ROAD SAFETY AUDIT

Intersection of Bay Road, Chestnut Street, Depot Street,
Standish Street, and Washington Street
(Hall's Corner)

Duxbury, Massachusetts

October 16, 2023

Aerial view of Hall's Corner in Duxbury showing traffic circle in the center and five intersecting streets.

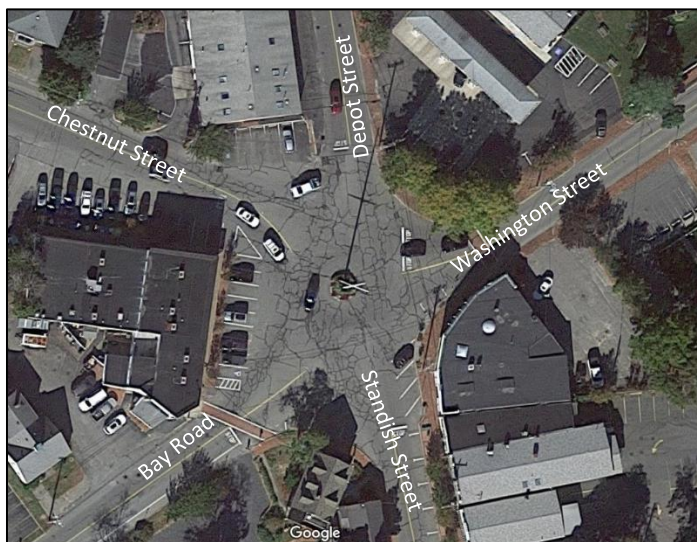
Safety Issue: There is a lack of formalized traffic control and operations leading to driver confusion and conflict as motorists enter the intersection from all five approaches. Although the intersection

has a STOP sign on Bay Road, Standish Street, Washington Street and Depot Street approaches, there is a lack of traffic operation control on the Chestnut Street approach except for a pavement marking on this approach for a YIELD control. The designated angled parking on this Chestnut Street approach encroaches on the travel lane. In addition, the parking spaces and lack of curb delineation result in a lack of location for placement for the YIELD sign on the approach. Vehicles entering the circle on all approaches have only a “keep right” sign at the bottom a short wall around the center flagpole circle to inform of the traffic flow direction around the circle. Tractor trailers lack turning radius for left turn movement as they enter from Chestnut Street to go around the circle and turn left to destinations on Depot Street (Duxbury Marketplace). Crashes have occurred due to the back end of the trailer hitting the circle wall as tractor trailers make this movement. Left turns from Chestnut Street to Depot Street have been observed to happen inside the circle rather than around the center circle.

The only control on the Chestnut Street approach is YIELD pavement markings. The proximity of the angled parking results in no available location to post a YIELD or STOP sign.

The only control indicating traffic flow direction in the circle is a “Keep Right” sign on the low wall around the flagpole in the center.

Safety Issue: There is a wide pavement area on the Bay Road and Washington Street approaches and an extensive wide area of pavement for vehicles to travel through the intersection from all approaches (approximately 160 by 90 feet of width). This wide area in combination with lack of pavement markings creates driver and road user confusion.

Enhancement: Consider a formal Intersection Control Evaluation (ICE) for potential “mini-roundabout” (or other potential traffic control such as signals) and retro-fit the approaches and central circle to include a mountable apron, splitter islands, signage, and pavement markings for yielding and channeling traffic. A gasoline station will be reopening at the northeast corner between Washington Street and Depot Street, which should be considered before making any adjustments. Tighten the inner circle wall thereby making it smaller to prevent the back ends of tractor trailers from hitting during left turn movements from Chestnut Street to Depot Street. In addition, adding bike lane and more pedestrian friendly crossings and spaces would enhance the viability of movement at Hall’s Corner for all users.

Enhancement: Evaluate pavement markings, signs on all approaches, advanced warning, and traffic control, to create a traffic control plan and sign plan for channeling traffic around the circle. Consider street design with geometric changes to accommodate and provide safe movement for all road users.
